#2016-10 Kensington Subdivision – Rezoning, Comprehensive Plan Amendment, Preliminary Plat, Preliminary PUD and Variations Project Review for Planning and Zoning Commission

Meeting Date: April 20, 2016

PRELIMINARY PLAT KENSINGTON SUBDIVISION

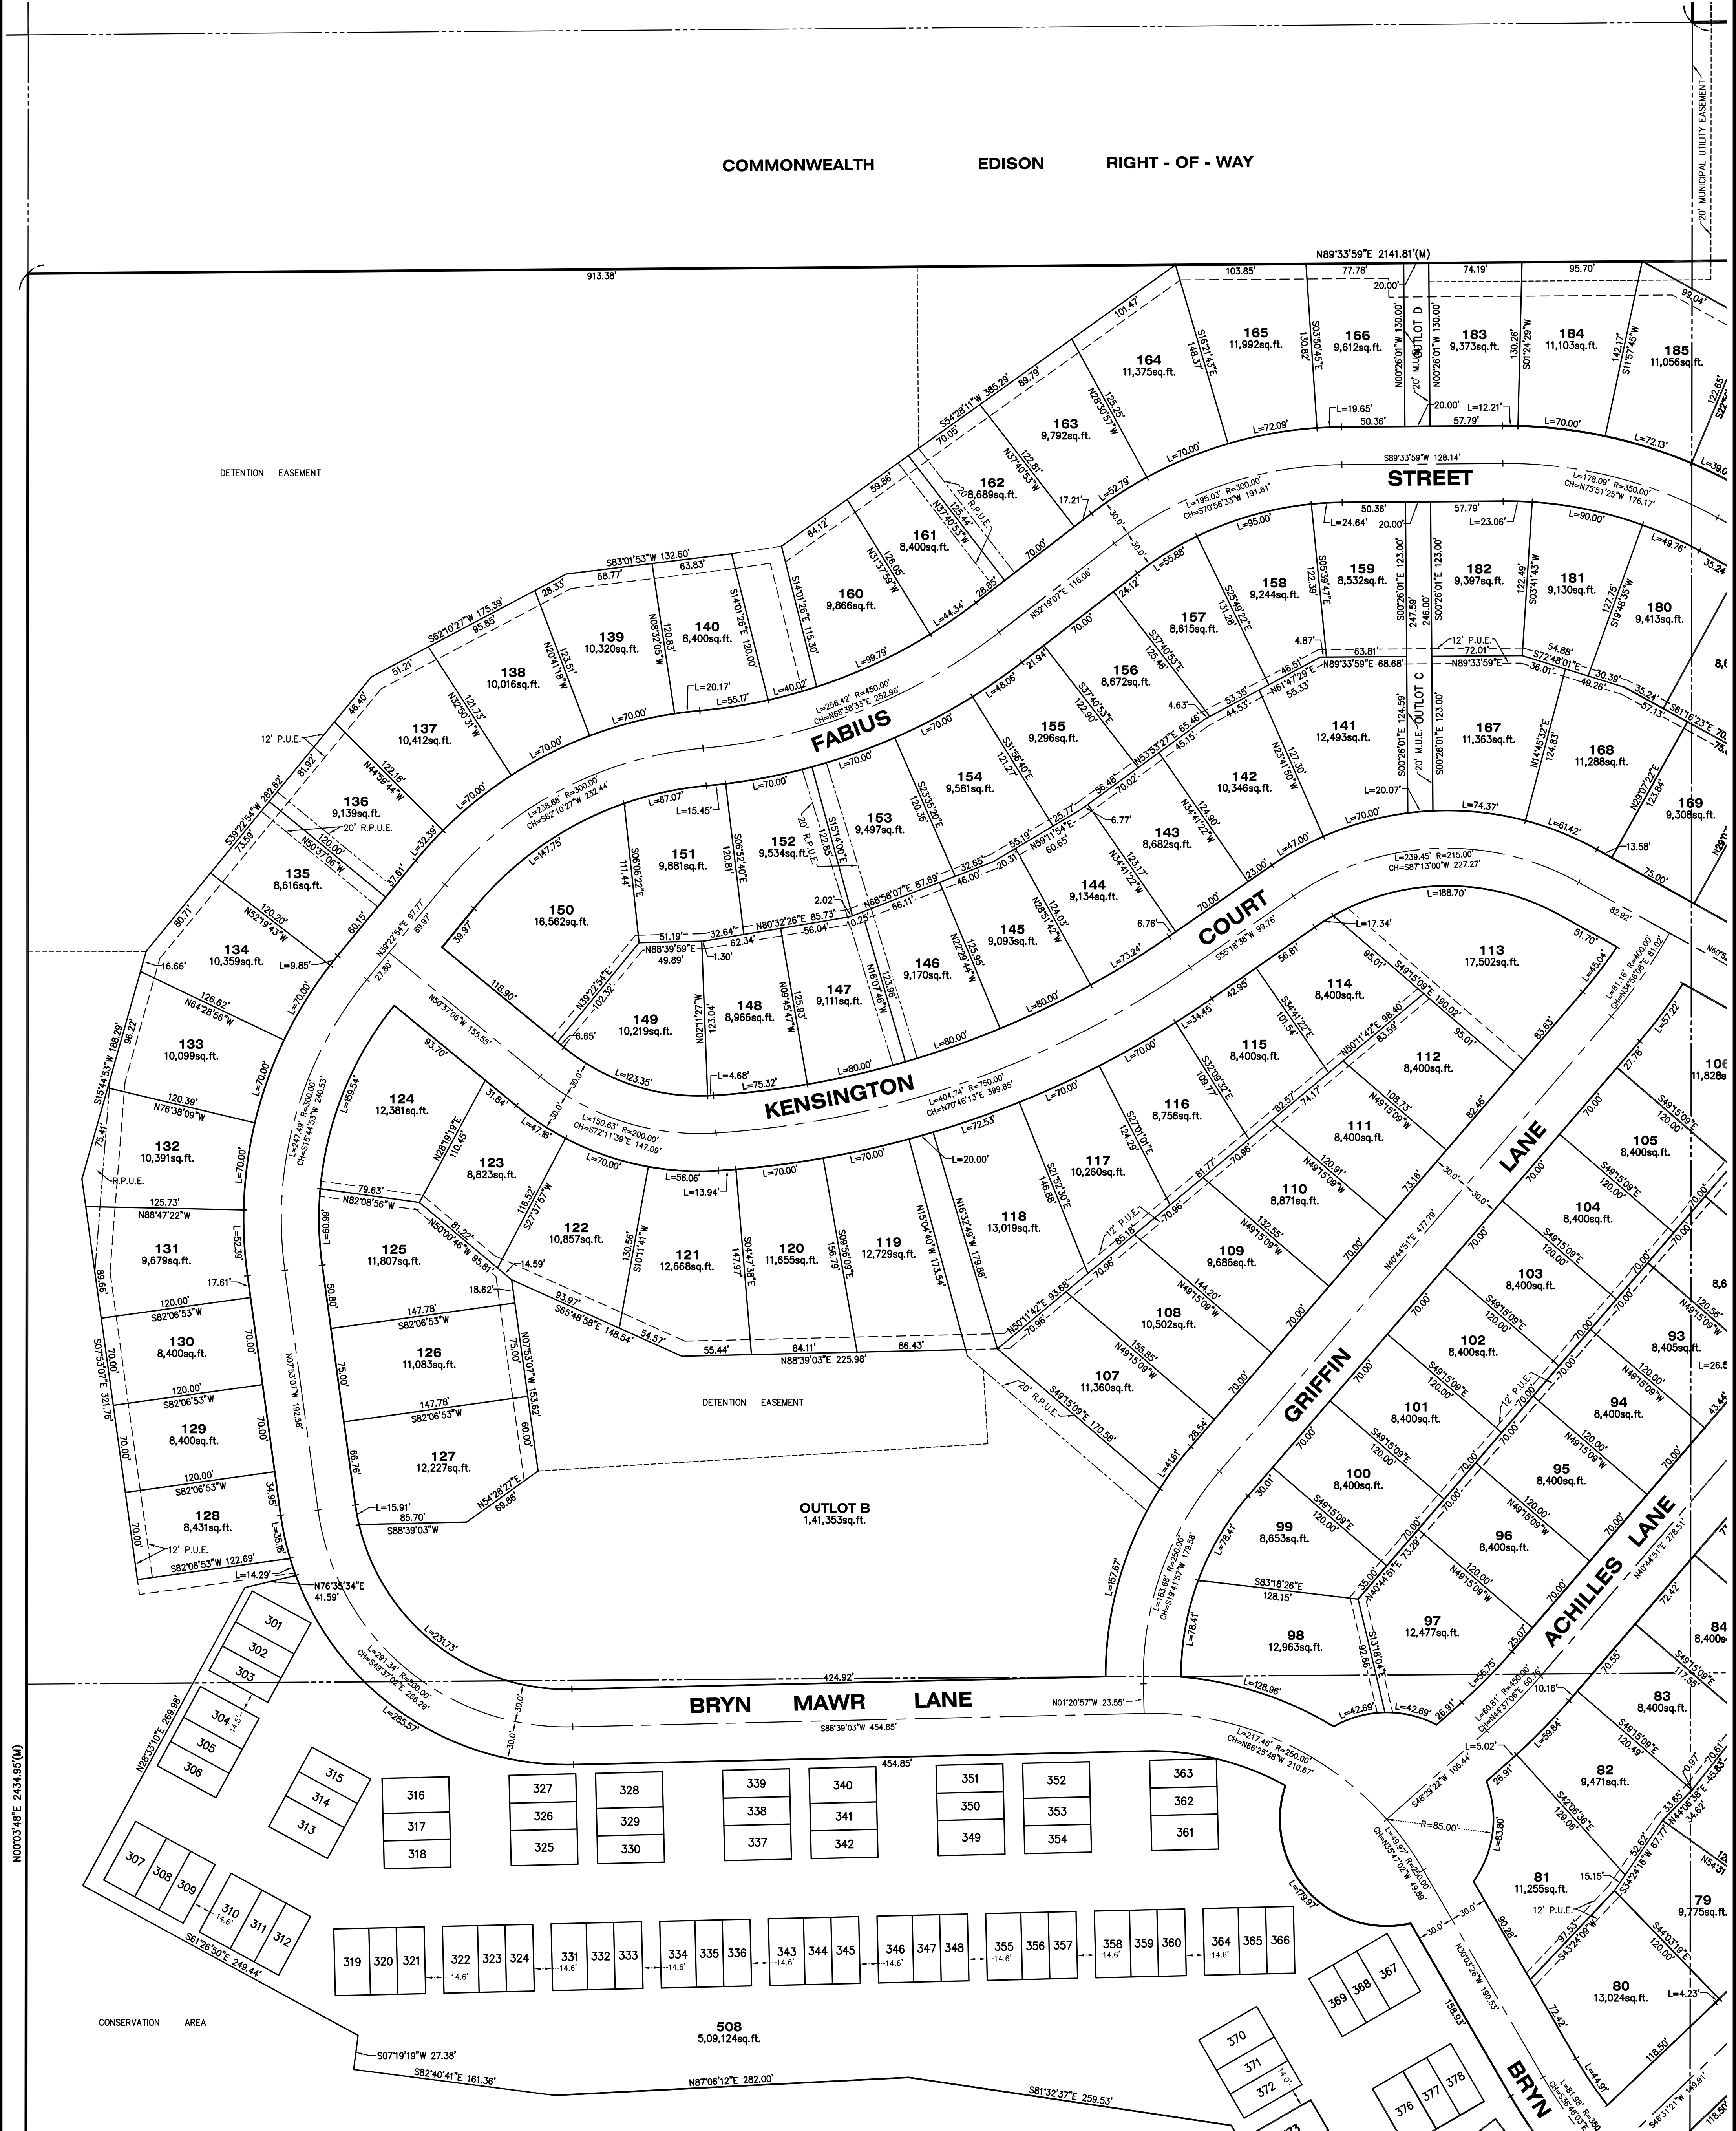
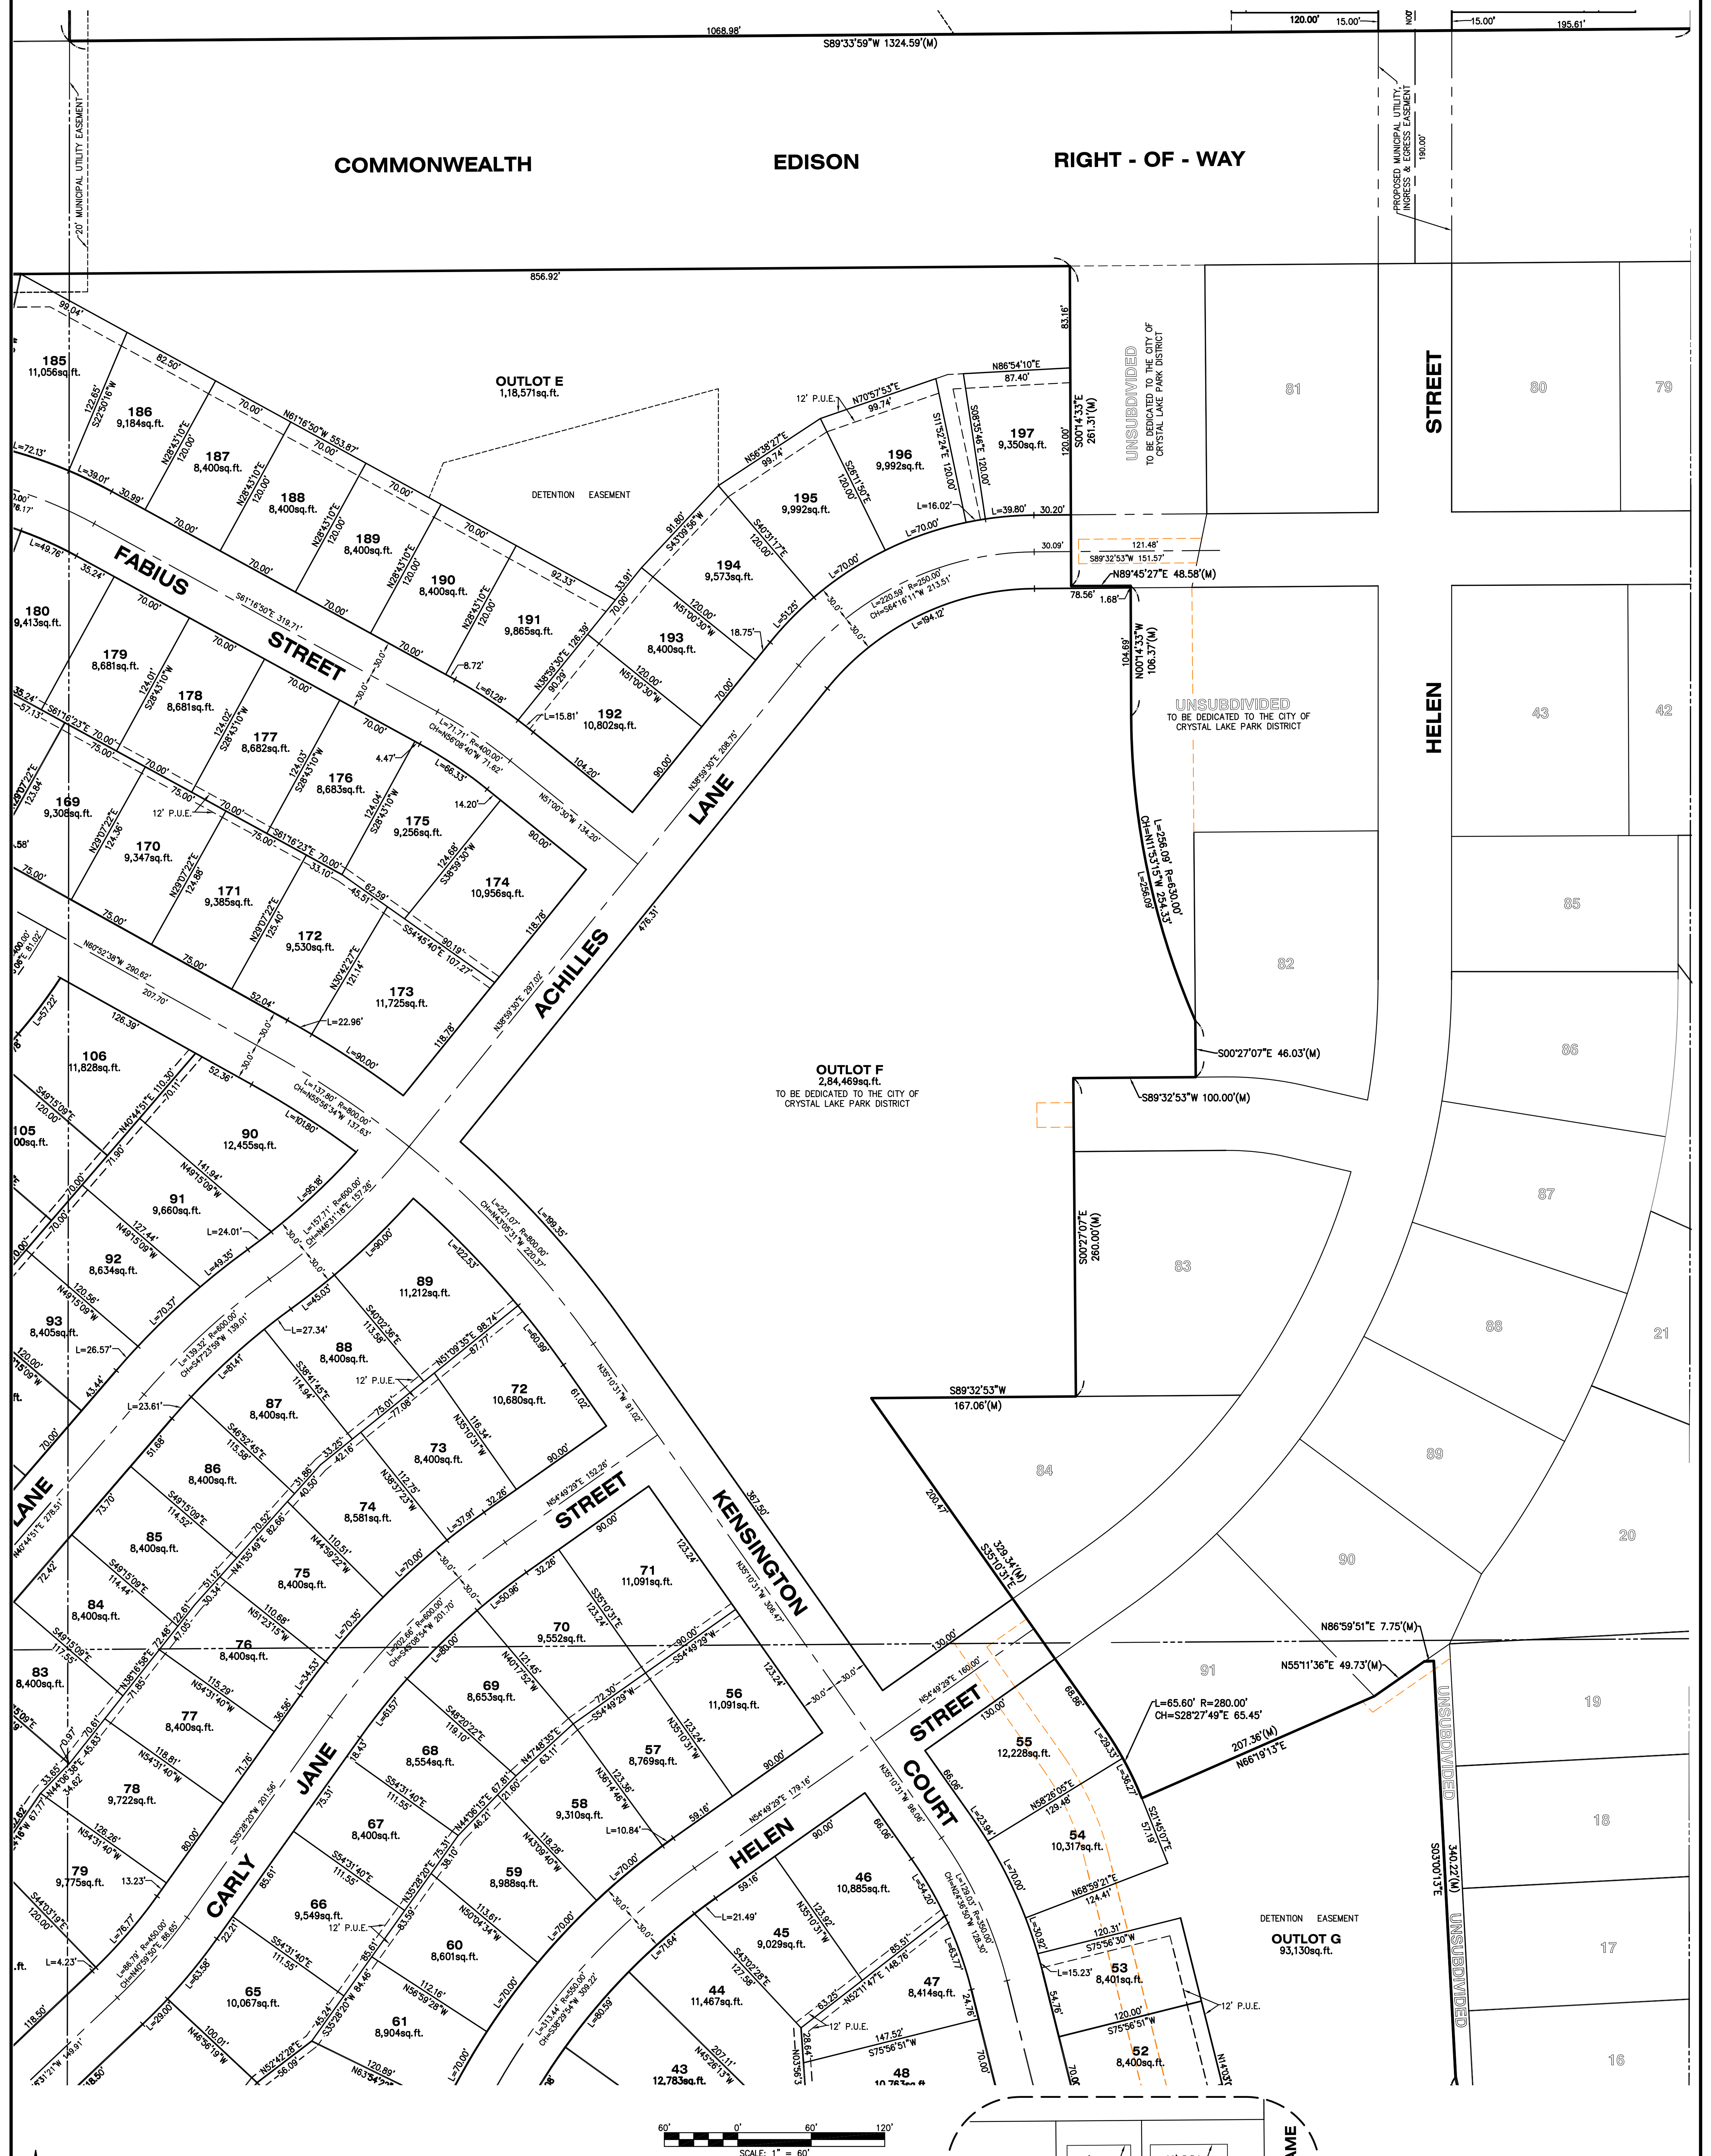
- R. Tree Survey (Urban Forest Management, dated 03/29/16, received 03/29/16)
2. Preliminary Plat of Subdivision:
 - A. Add notations to all roadways on the plat, "hereby dedicated" for the public roadways and "private drive" for private roadways.

- B. Add notations to previously dedicated roadways.

- C. Public streets must be 28 feet wide, measured edge to edge, with a 2-foot shoulder striped on each side instead of the ribbon curb.
 - D. The private streets for the townhomes shall have street names that will be approved by the Fire Rescue Department. Each separate section of townhomes should have a different street name.

- E. Kensington Court is not an approved street name. Provide an alternate name for consideration.
 - F. The new Fabius Street section will need to be renamed since the existing Fabius Street will not be extended. Provide an alternate name for consideration.

- G. Bryn Mawr Lane shall end at the intersection with Helen Street (east side) and the remainder of the street shall be renamed the alternate name as required in condition 2.D.

- H. Eliminate the driveway access to Bryn Mawr Lane between townhomes 459 and 470.
 - I. Provide cross connection between townhomes 474-437 the two townhome groupings with a private access.

- J. The emergency access to the portion of the subdivision located north of the ComEd easement shall 20 feet in width, constructed with an approved surface and must be maintained by the HOA. Gates at both ends are required to restrict motorized use and must be approved by the Fire Chief.

- K. Each outlot should be labeled with the intended use, “conservation easement”, “drainage easement”, etc.
 - L. The interior of the roundabouts shall be outlots and maintained by the HOA.

- M. Lot 505 shall be renamed as Outlot L.
 - N. Lot 506 shall be renamed as Outlot M.
 - O. Adjust the townhome layout to provide guest parking for the townhome lots 399-512.

- P. The “unsubdivided parcel” to the north of Achilles Lane and adjacent to the edge of Bryn Mawr Phase I needs to be labeled as an outlot and included in the development.

- Q. The zoning district noted on the plat of subdivision is R-2, add PUD and include R-3B PUD and B-2 PUD.
 - R. Add building setback lines to all lots on the preliminary plat of subdivision.
